ADDENDUM

NO. 2

PROJECT: Raymond Community Centre, Washroom Addition /
Renovations, Muskoka Lakes Township

PROJECT No: 19-36

DRAWN	D.R.	SHEET NUMBER
CHECKED	D.R.	E-1
SCALE	1/4" = 1'-0"

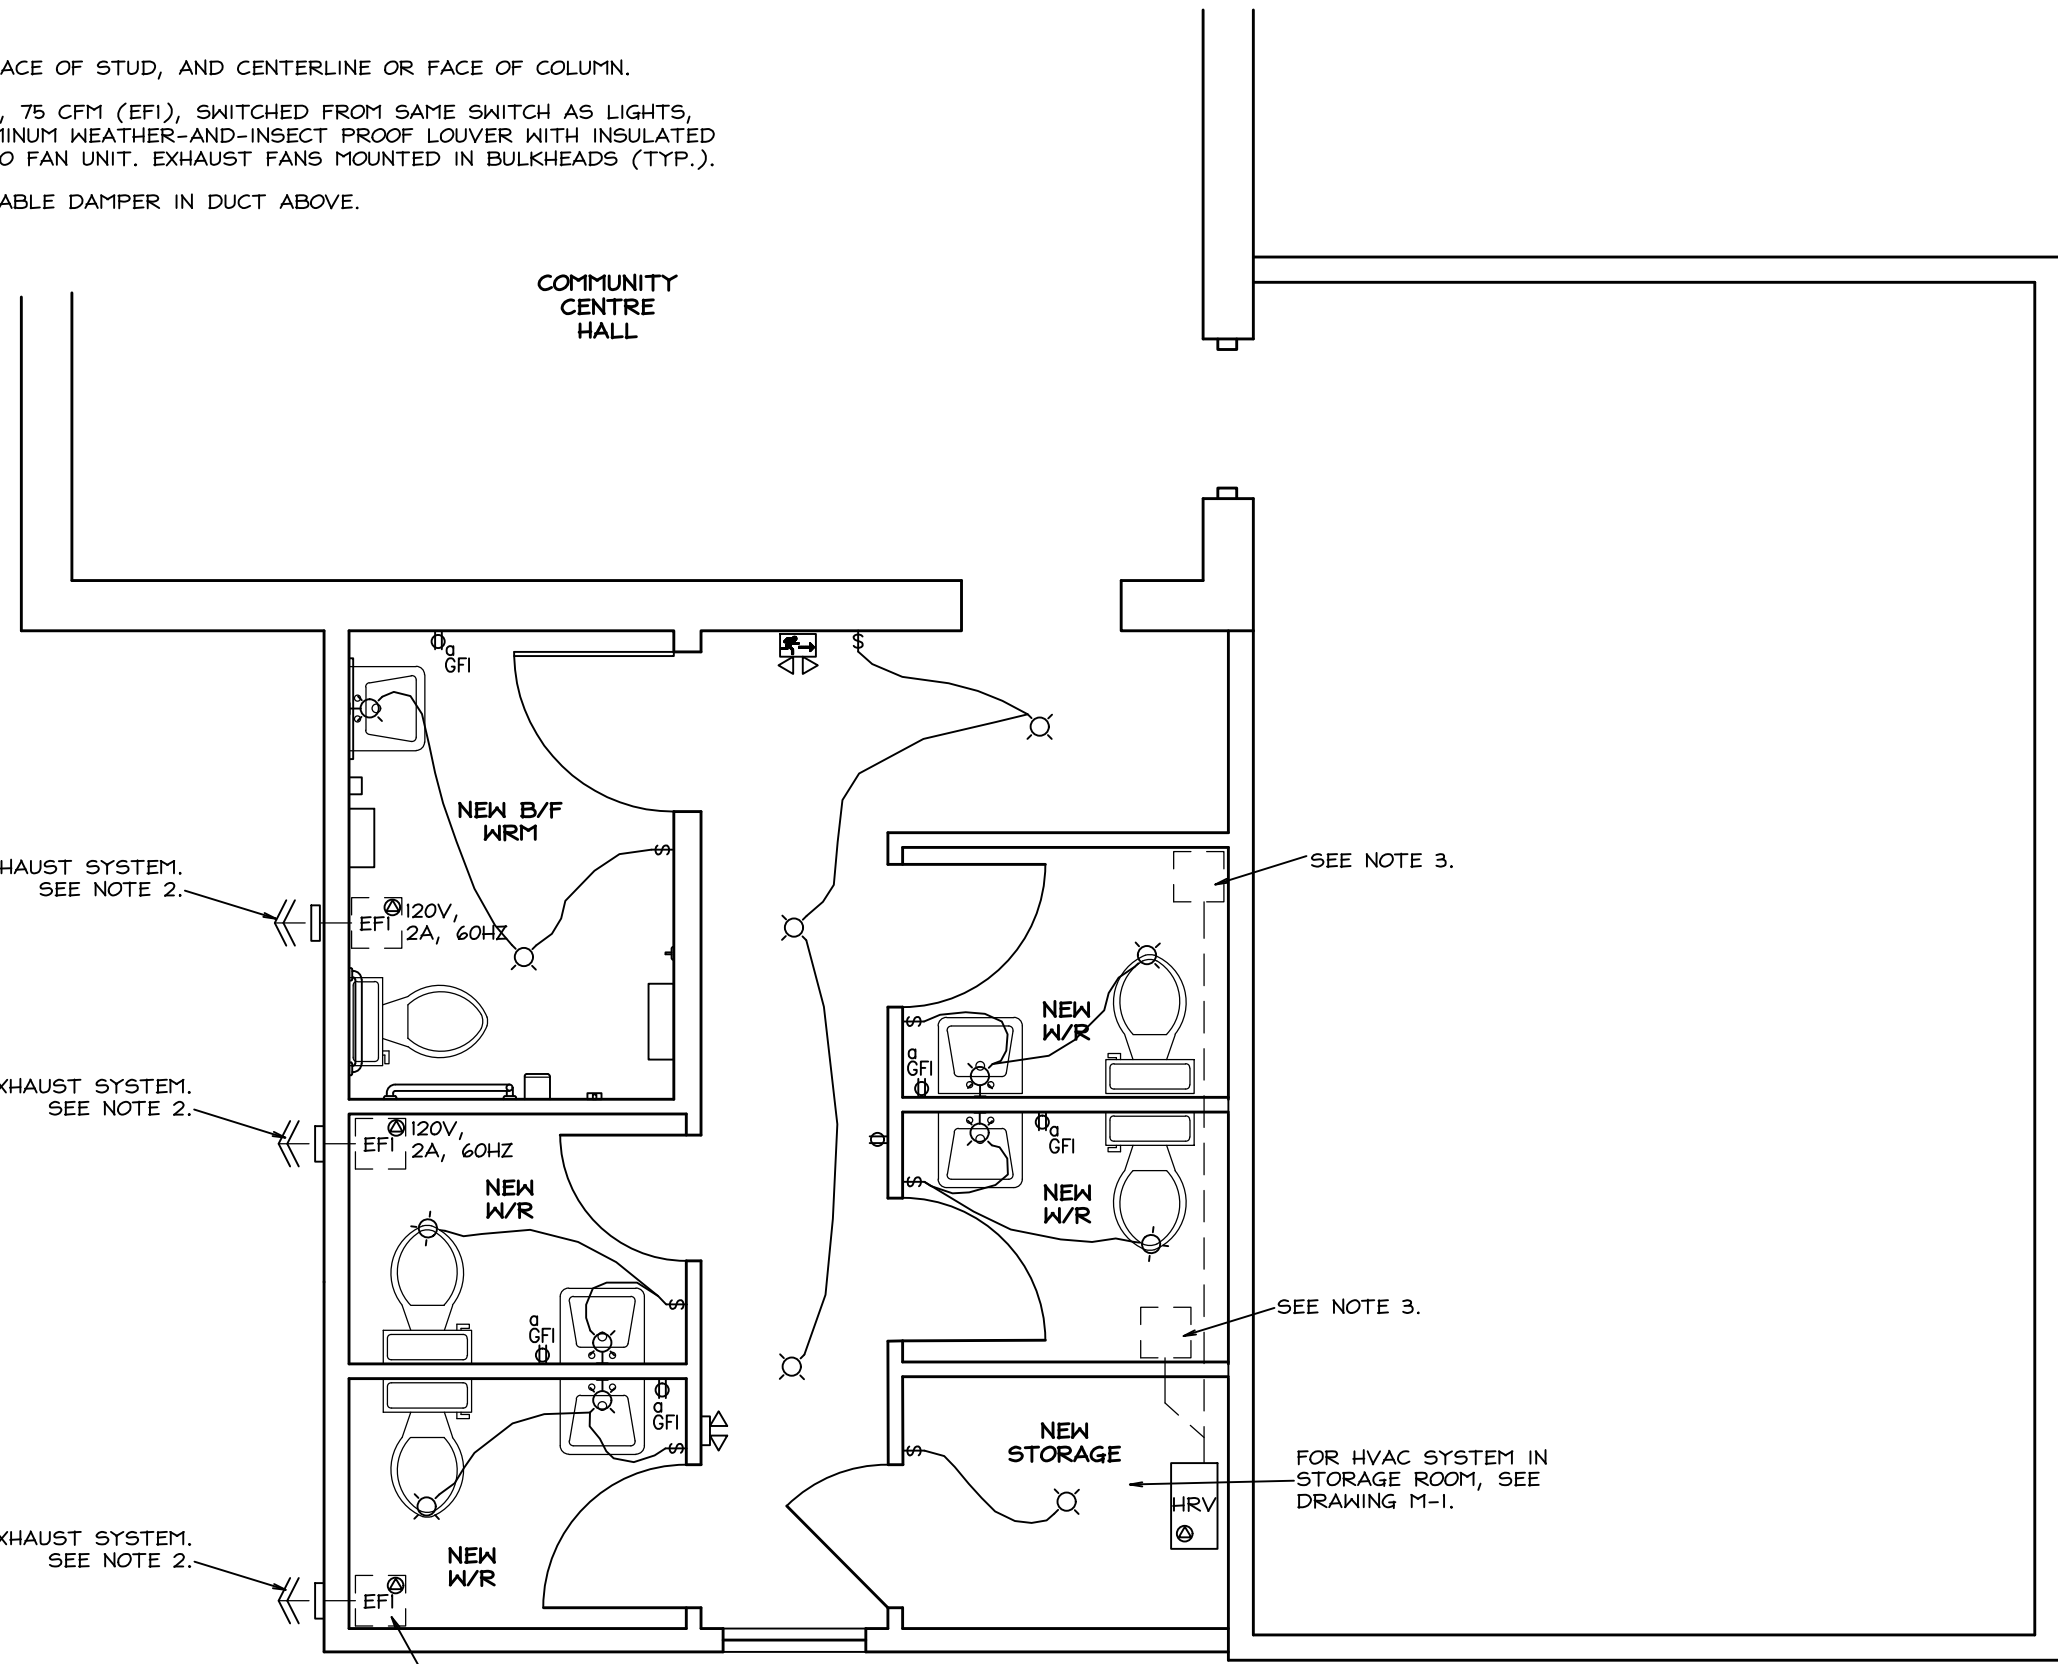
2. Drawing E-1 (Revision #3) is enclosed with this addendum. Delete previous versions of drawing E-1.
3. Apply continuous strips of butyl tape to all seams between panels in the sheet steel roofing.
